Re: ZMAP 2010-0001 and SPEX 2010-0003, HS-7 Dulles South and Elementary School, Goshen Road Assemblage, Response to Second Review Referral Comments

**Loudoun County Public Schools
HS-7 Dulles South and Elementary School
ZMAP 2010-0001, SPEX 2010-0003
Response to Second Referral Comments
July 22, 2010**

SUBJECT: Dulles South High School (HS-7) and Elementary School (ZMAP 2010-0001 and SPEX 2010-003)
– Supplemental Analysis: Response to OTS Comments

Figure 1
Gum Spring Road and Braddock Road

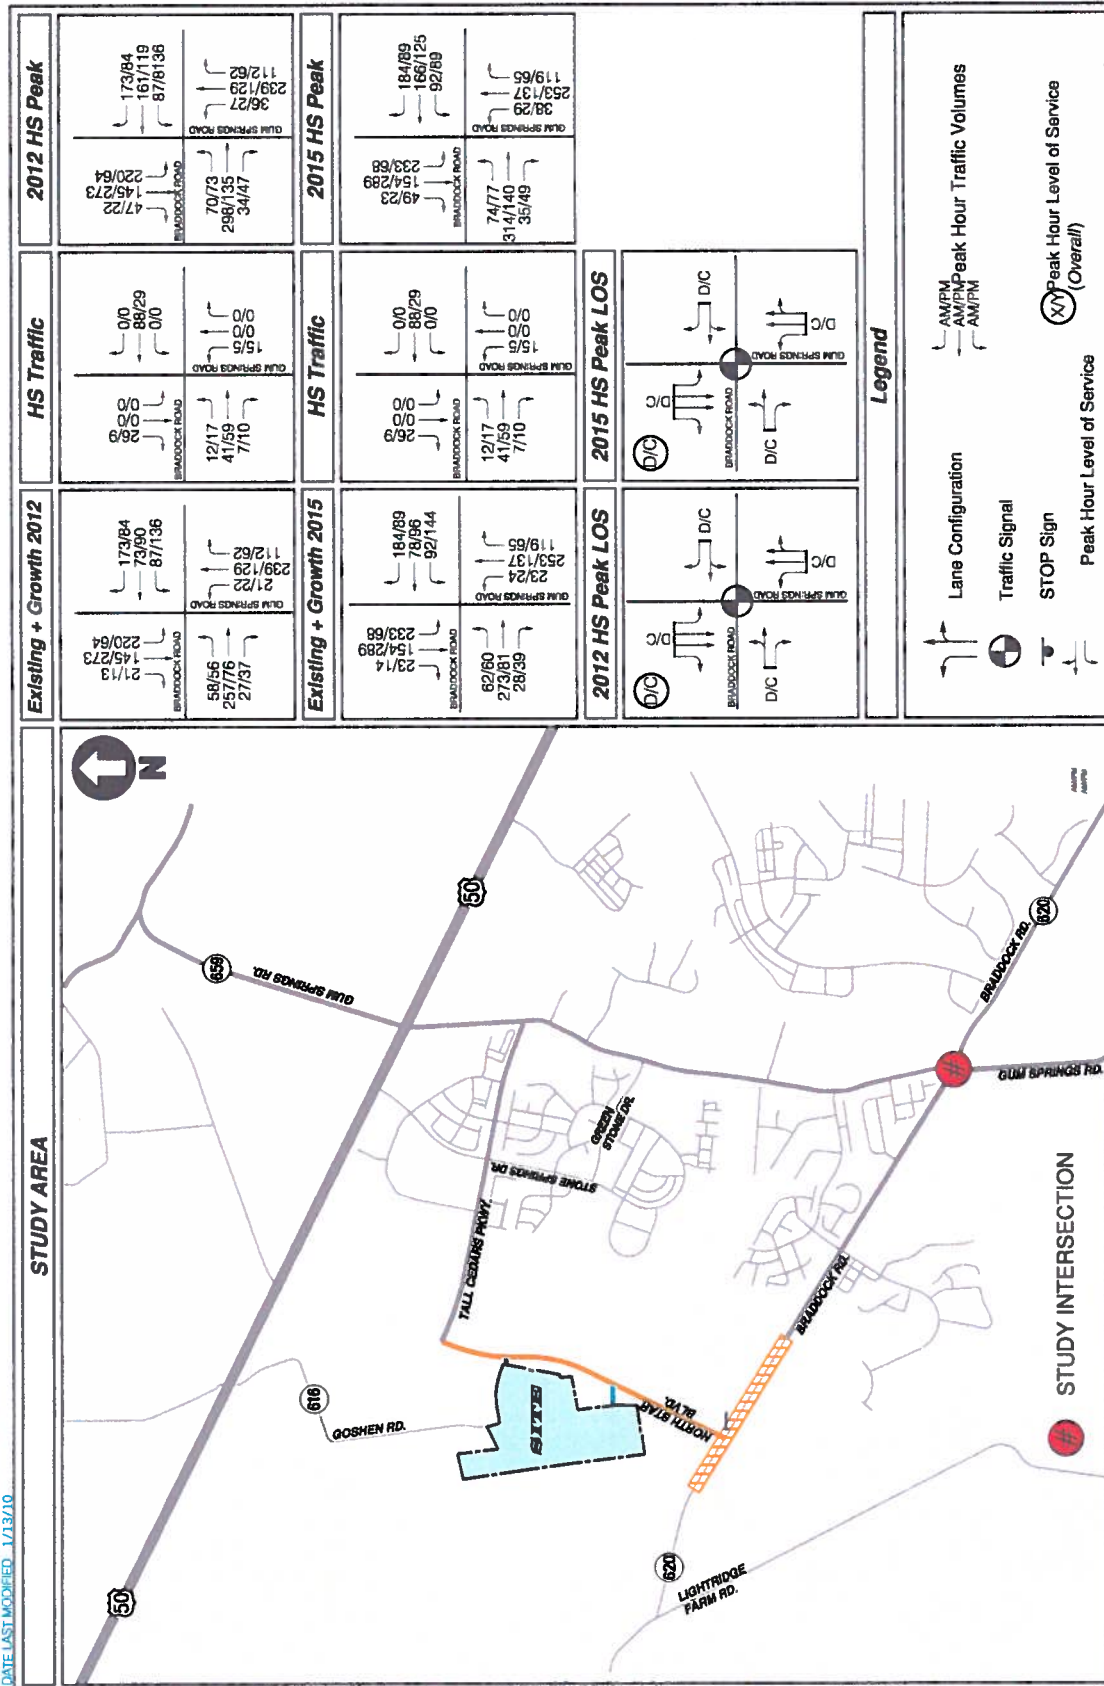
Comment #6 from the OTS referral states – ‘If not already constructed by others prior to the opening of the high school in 2012, the Applicant should construct the turn lanes recommended by the traffic study at the Gum Spring Road/Braddock Road intersection. Any necessary modifications to the existing traffic signal at this intersection should also be the responsibility of the Applicant if such modifications have not already been made by others. The Applicant should seek reimbursement for these improvements/modifications to the extent that they have been proffered as part of other developments in the area.’

At the meeting with OTS staff, it was discussed that as the analysis in the traffic study accounted for traffic generated by the background developments, including the background developments listed above; there is a certain level of ambiguity with respect to the volume/capacity thresholds for these improvements. Hence, an analysis was conducted with the existing traffic, regional growth and the traffic generated by the proposed schools to evaluate exact level of impact from the school traffic at this intersection, without assuming the improvements listed above and without assuming traffic generated by approved developments in the area.

The existing volumes, inherent regional growth rates, and the school traffic distribution were maintained as presented in and consistent with the traffic study, dated June 9, 2010. Table 1 below presents the capacity analysis results.

Figure 1 on the next page shows the traffic volumes, capacity analysis results and lane configuration assumed for the intersection of Gum Spring Road and Braddock Road. The traffic count sheets and the capacity analysis Synchro worksheets are attached in the Appendix section.

Figure 2
Stone Springs Boulevard and Tall Cedars Parkway

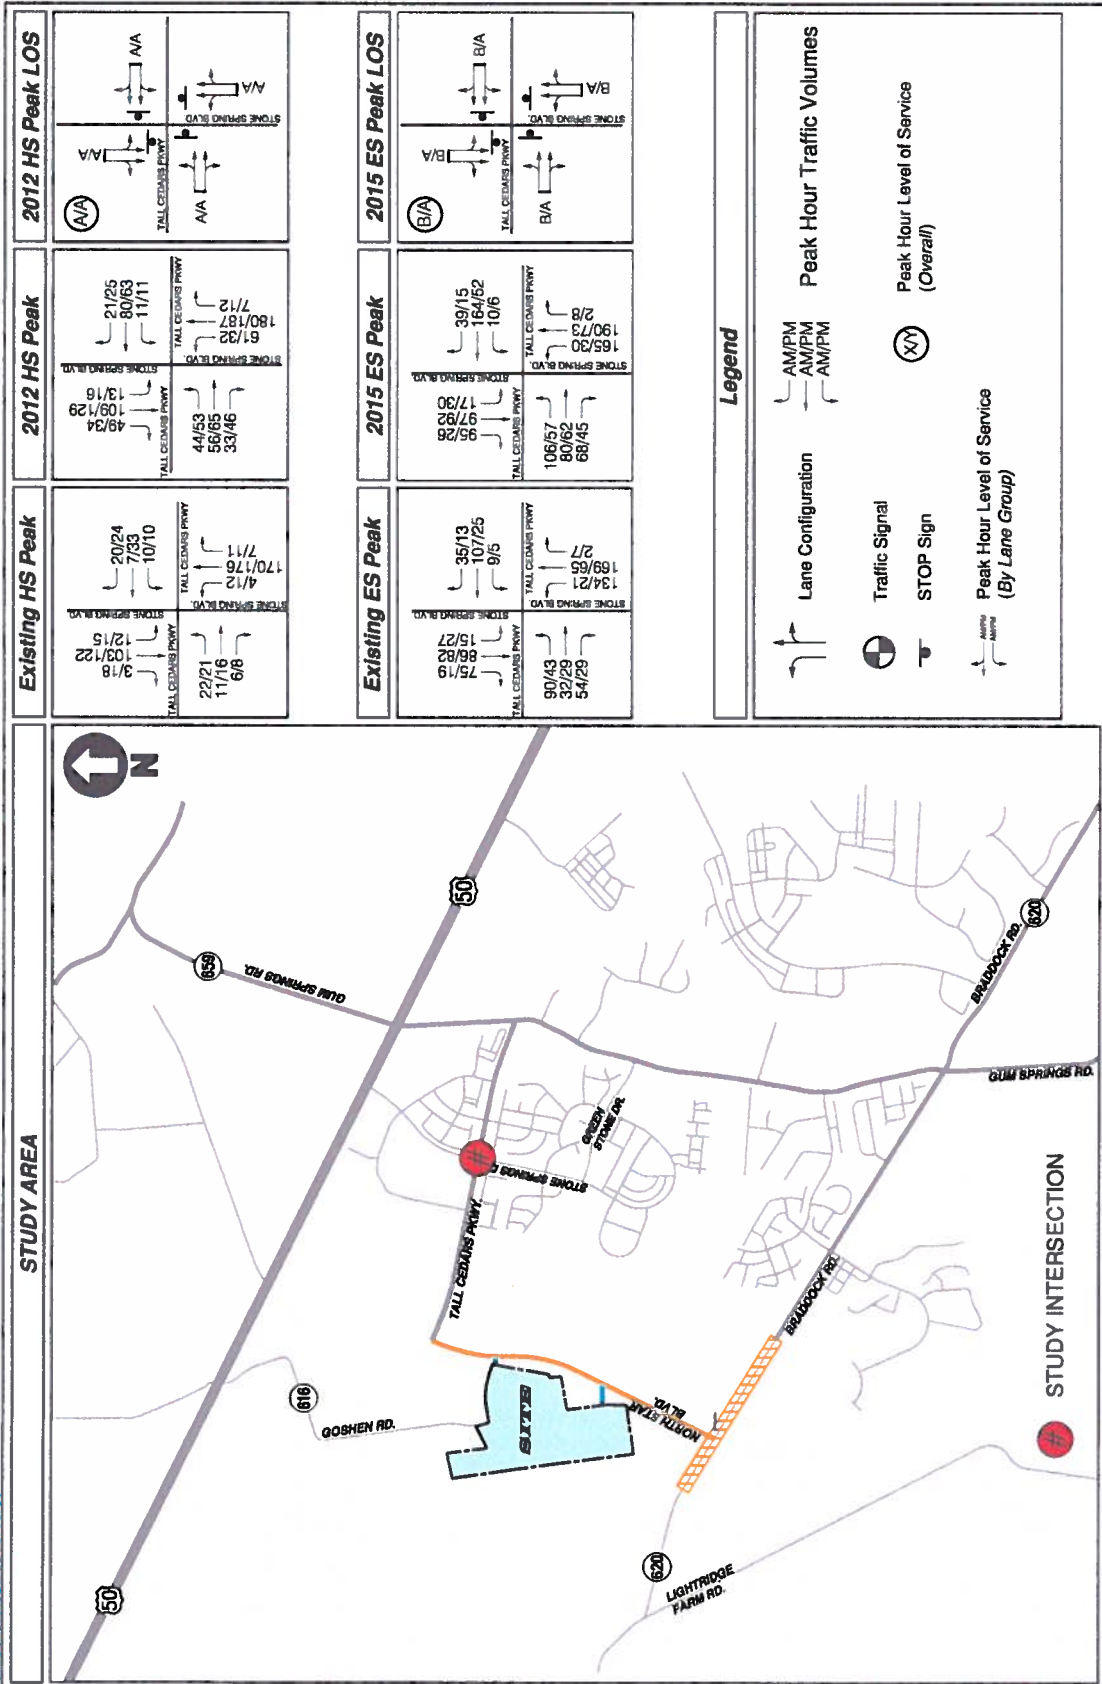
Comment #11 from the OTS referral states – ‘While not included in the scoping agreement, a significant percentage of high school site-generated traffic is anticipated by the traffic study to go through the Stone Springs Boulevard/Tall Cedars Parkway intersection. According to the June 2009 traffic study for the Stone Ridge Commercial rezoning (ZMAP 2006-0011), certain movements at this intersection are forecast to operate at failing LOS (LOS E or F) by 2015 even without the proposed schools in place. The Applicant should analyze the intersection and identify and commit to necessary mitigation measures to maintain/restore acceptable LOS (LOS D or better) at this intersection.’

In order to address this comment, this memorandum presents the results of the analysis conducted at the intersection of Stone Springs Boulevard/Tall Cedars Parkway under future conditions with development – HS Peak Hour (2012), and future conditions with development – ES Peak Hour (2015). The School Board’s adopted catchment area was utilized to evaluate the capacity analysis results. The background traffic generation and distribution was maintained consistent with the June 9, 2010 traffic impact study. Traffic counts were conducted at the intersection of Stone Springs Boulevard and Tall Cedars Parkway on Thursday, November 19, 2009. Table 2 below presents the capacity analysis results.

Figure 2 on the next page shows the traffic volumes, capacity analysis results and lane configuration for the intersection of Stone Springs Boulevard and Tall Cedars Parkway. The traffic count sheets and the capacity analysis Synchro worksheets are attached in the Appendix section.

ROAD "A" TYPICAL SECTION
(NOT TO SCALE)

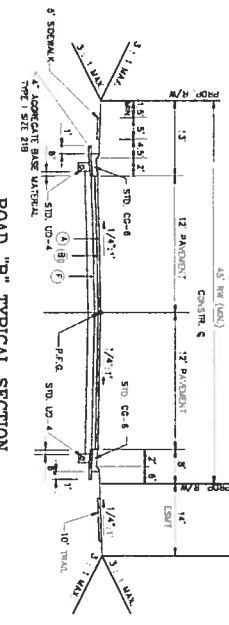
Comment 3: Provide typical sections for Roads “A” and “B” compliant with the applicable VDOT standard. Reference the standard used and include street width, design speed and projected traffic volume.

Response: The typical sections for Roads A and B have been added to the SPEX Plat as requested.
